Access Compliance Report

Public Rights-of-Way

| Intersection ID: 44333 | Main Street: BROWNE_RD | Cross Street: RETRIEVER_WY | Location: NE |
| ADA ID: 2236388B545E | Ramp Type: Perp | Initial Pass/Fail: Fail | Overall Compliance: No |

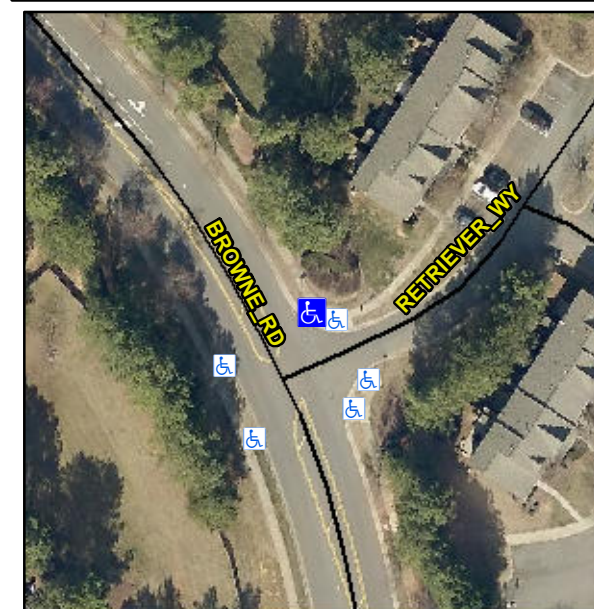
R304.2.2

| Compliance | Description | Data | Compliance | Description | Data |
|------------|-----------------------|------|------------|-----------------------------|------|
| N/A | Ramp Length (in) | 65.0 | No | Ramp Slope (%) | 11.7 |

Remove & Replace Entire Ramp.
